4-E-20-HZ
APPLICATION FOR CERTIFICATE OF APPROPRIATENESS

211 16th St. 37916
 Ft. Sanders NC-1

Staff Report - Certificate of Appropriateness Application

File Number: 4-E-20-HZ

East:

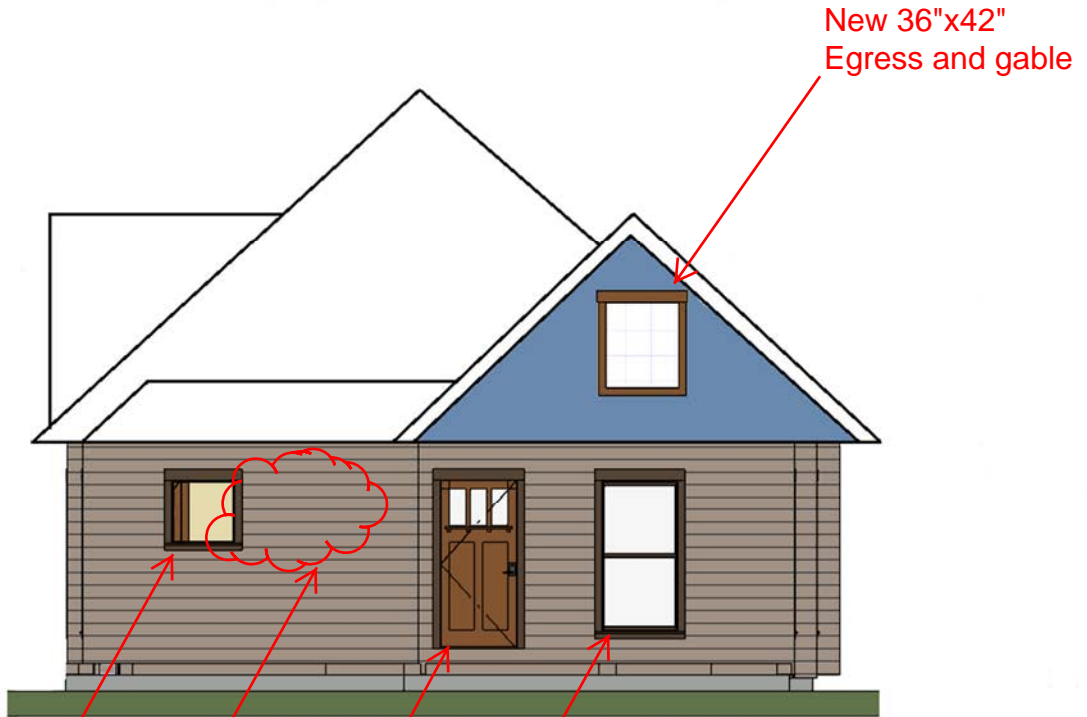
5. The proposed egress windows meet the minimum size requirement for building code. While applicant has installed egress windows in side gable fields in multiple instances in the Fort Sanders overlay, a full-sized egress window of 36" by 42" is not appropriate for the façade front gable. The proposed egress window would be too large for the historic proportions of windows.

- 1) omit egress window in façade (east) gable field (smaller casement window for natural light, if necessary, could be approved by staff;
- 2) specifications on north elevation dormer addition measurements be submitted to staff for approval;
- 3) windows on right (north) elevation remain in existing locations;
- 4) retain window on left (south) elevation;
- 5) if foundation must be reconstructed in locations other than the front porch and rear addition, a revised application for a COA must be submitted.

North:

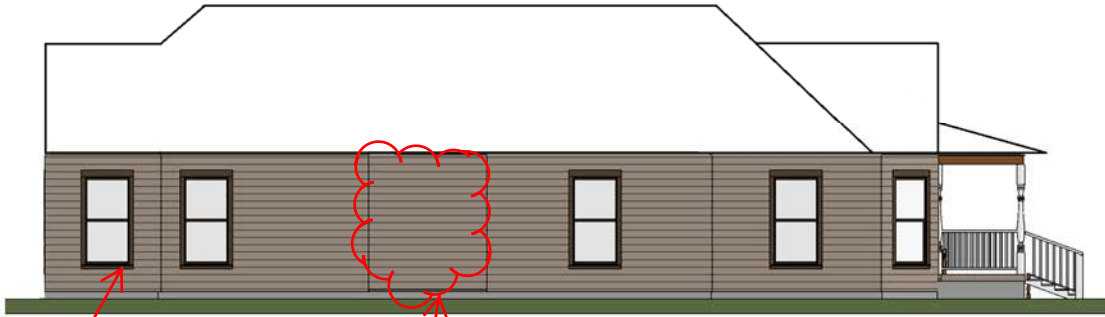
4. A gable-roof dormer addition is proposed for the right (north) side elevation. The guidelines state "additions should be made to the rear or side of the building." The adjacent houses at 207 and 215 16th Street demonstrate similar side elevation gables which intersect the primary hipped rooflines. The dormer addition should be proportionate to the existing house; specific measurements should be provided to staff to confirm.

7. Moving the two historic windows on the right (north) elevation to serve interior purposes does not reflect "symmetry similar to historic styles in the neighborhood." Removal of the window on the left (south) elevation creates a large swath of wall space with insufficient transparency.
